Courtyard enclosure study · closing the conditioned house around the open courtyard · Taif / Palm House V6.3

Design review Y-01 (critical) · study only: no CSV, plan or 3D file changed · the owner decides · 30 Oct 2026 · the windows follow `docs/DESIGN_LANGUAGE.md` (black steel, divided lites)

Plans of the gallery strip, first floor · now / A / B · the sky opening and the void · about 1:115 on A4

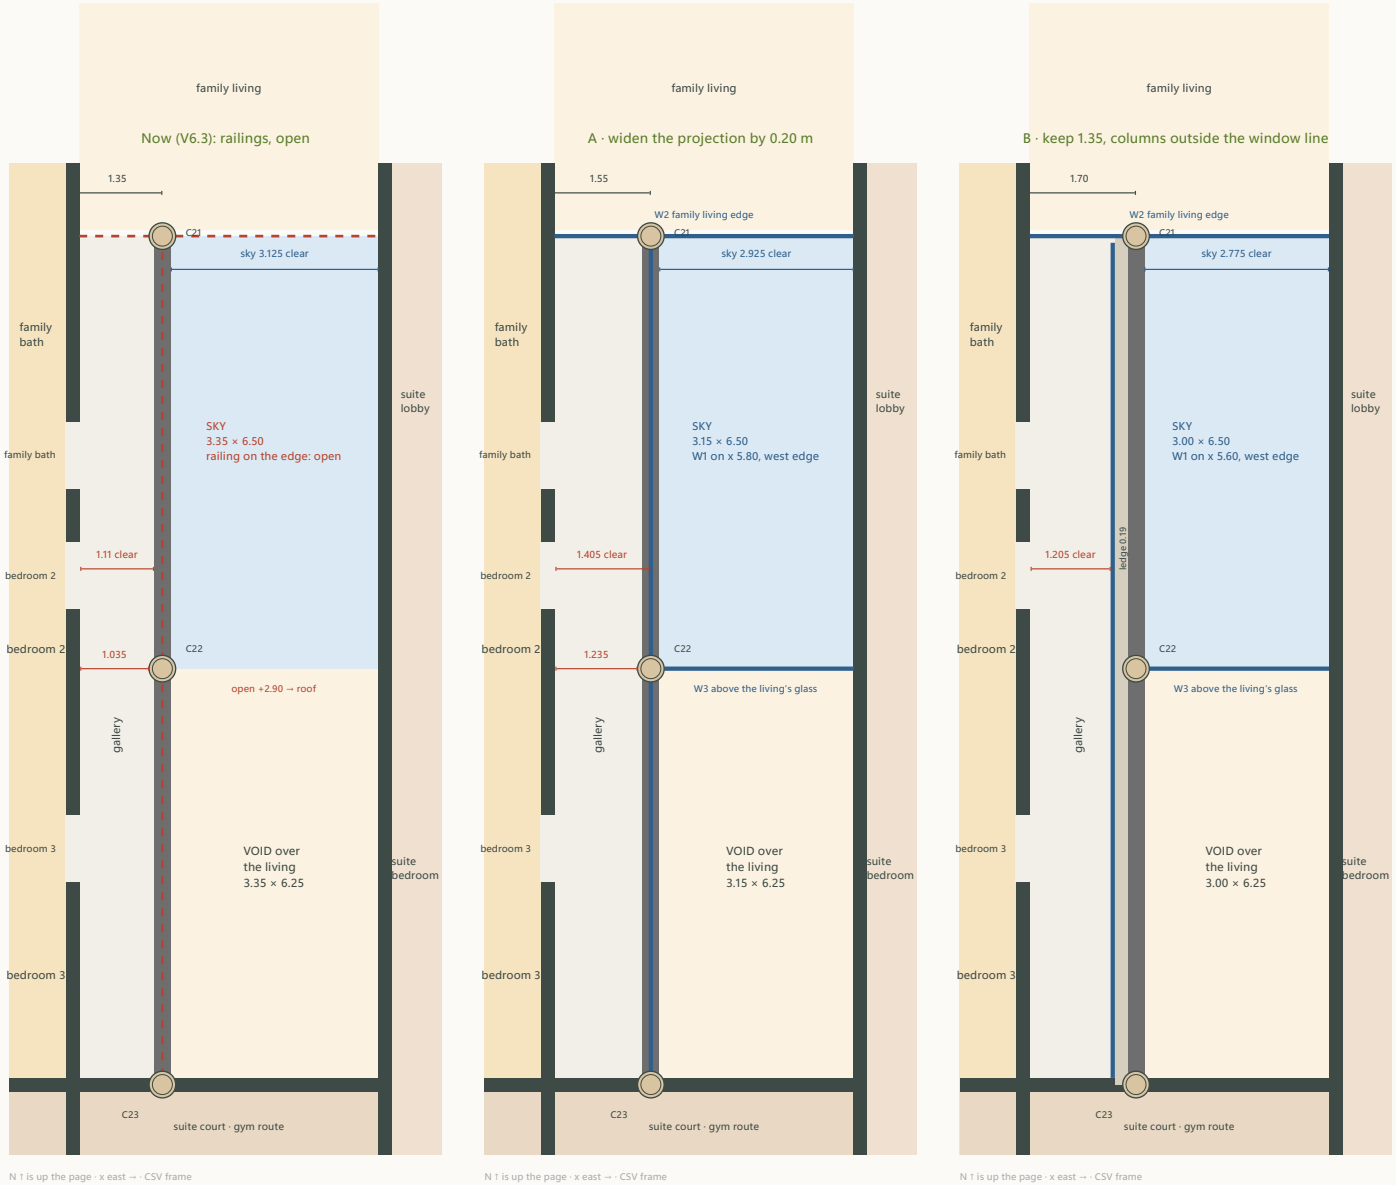
Today the gallery is 1.11 m clear between the rooms' finished wall face (x 4.365) and the upstand of B3, and 1.035 m at the three stone column sleeves (Ø0.4). A window on the line changes little by itself; the columns are the problem. Two ways to reach 1.20 m:

Item	Now (V6.3): railings, open	A · widen the projection by 0.20 m	B · keep 1.35, columns outside the window line
Projection on axes (x 4.25 → edge beam)	1.35 m (edge x 5.60)	1.55 m (edge x 5.80)	1.70 m (edge x 5.95)
Window line	—	x 5.8	x 5.6
Columns C21–C23 (stone sleeve Ø0.4)	x 5.6, in the line	x 5.8, in the line	x 5.95, 0.35 m outside the glass, free-standing
Gallery clear · minimum	**1.035 m** ✗ (< 1.20)	**1.235 m** ✓	**1.205 m** ✓
Gallery clear · at the columns	1.035 m	1.235 m	1.205 m
Gallery clear · at the window / railing	1.11 m	1.405 m	1.205 m
Gallery clear · at the bedroom doors	1.11 m	1.405 m	1.205 m
Sky opening, axes (clear · at the columns)	3.35 (3.125 · 3.05) m	3.15 (2.925 · 2.85) m	3.00 (2.775 · 2.7) m
Sky opening area, axes	21.78 m² (—)	20.47 m² (−6 %)	19.5 m² (−10.4 %)
Double-height void, axes (clear)	3.35 (3.125) m	3.15 (2.925) m	3.00 (2.775) m
Well: depth to the roof railing / width	2.48	2.63	2.77

Dark: walls and the edge beam B3 (0.25 wide, upturned 0.30 above the slab). Blue lines: the new steel windows W1 / W2 / W3; red dashed: the open railings of today. Columns: the stone sleeve Ø0.4 round the Ø0.3 core. In B the beam and the columns leave the window line and a 0.19 m ledge lies between the glass and the beam (capped in stone, falling to the courtyard). The gallery doors are the V6.3 1.00 m openings.

A keeps everything on one line: the beam, the columns, the window and the railing base are the same element, the gallery is 1.405 m clear and 1.235 m at the columns, the sky loses 6 % of its area and stays 3.15 m wide on axes. **B** reaches 1.20 m with no margin (1.205 m), narrows the sky more (3 m: the beam and the roof edge must follow the columns), and adds a 0.35 m ledge outside the glass that must be waterproofed, capped and kept clean; its one real gain, free-standing columns in front of a glass wall, is a stronger colonnade image. If the owner wants that image, B is buildable; otherwise A. In both, the two-storey columns, the upturned B3 and R11 stay as decided (X8); only their x changes. **Study checks passed** (7)

Sections through the courtyard (y ≈ 10, looking north) · A and B · about 1:105 on A4

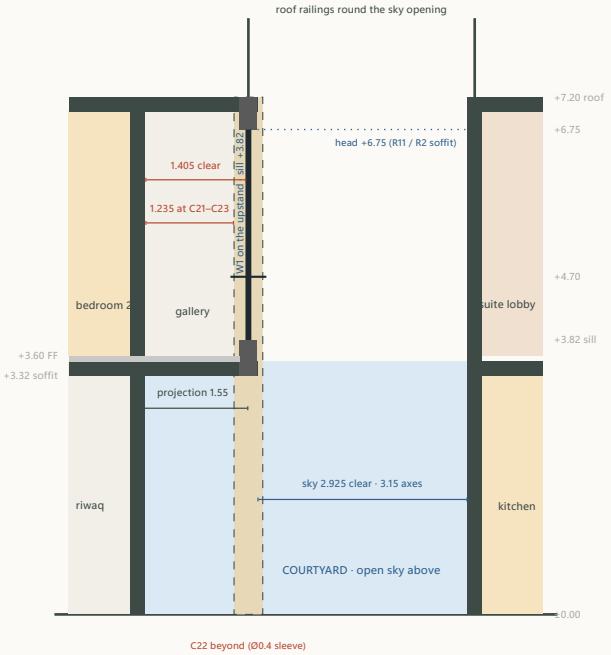
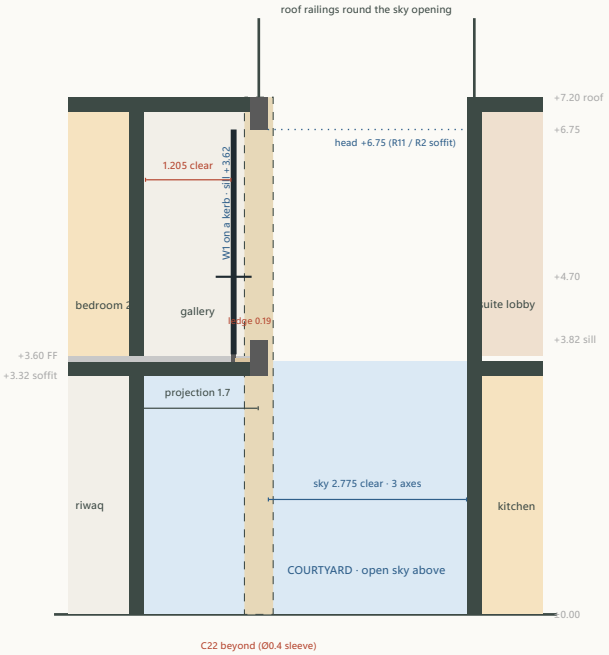
A · widen the projection by 0.20 m · section at y ≈ 10 looking north

B · keep 1.35, columns outside the window line · section at y ≈ 10 looking north

Dark: walls, slabs, the roof; grey: the upturned edge beam B3 (0.25 × 0.50 total, 0.30 above the slab) and the roof edge beam R11 above it; the dashed column is C22 (y 13.0) beyond the cut. W1 (heavy black line) sits on the upstand (A) or on a 0.10 m kerb inboard of it with a stone-capped ledge outside (B); its guarding transom at +4.70, its head at +6.75 under R11.

- **A:** B3, R11 and C21–C23 move 0.20 m east to x 5.8 the projection slab bay becomes 1.55 m (slabs-ff row "the projection"), the roof strip over the gallery 1.55 m (slabs-roof); C22 stays the pier in the living's courtyard glass (now at x 5.8), C21 in the women's majlis glass, C23 in the living's south wall; the spans (6.5 / 6.25) are unchanged, R2's west end lands on C22 at x 5.8. The sky opening is 3.15 × 6.5 m.

- **B:** B3, R11 and C21–C23 move 0.35 m east to x 5.95 the slab bay becomes 1.7 m with the window line 0.35 m inboard of the beam on a 0.10 m kerb; the ledge between the kerb and the upstand is waterproofed and capped (stone, falling out). The columns stand free in the courtyard and in the void: C22 is a free column in the living's courtyard glass line, 0.35 m in front of the upper window W3 (W3 then runs behind it, from the W1 line at x 5.6 to the kitchen wall, 3.25 m). Alternative B2 (not recommended): B3 stays at x 5.6 and reaches the columns at x 5.95 on short corbels; two lines of concrete for one edge.

W1 · the gallery line seen from the courtyard and the void (looking west) · option A · 1:70 on A4

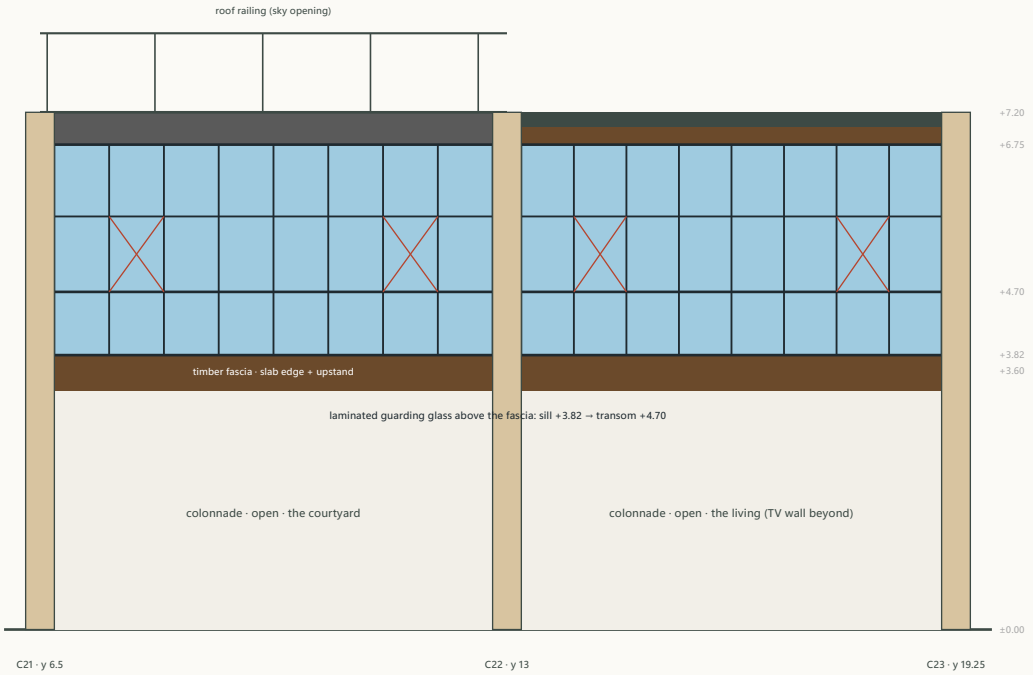
black steel, divided lites ≈ 0.75 wide · transoms at +4.70 (guarding) and +5.75 · red X = inward side-hung casements, two per bay (night mode, cleaning) · about 35.01 m² of glass · A · widen the projection by 0.20 m
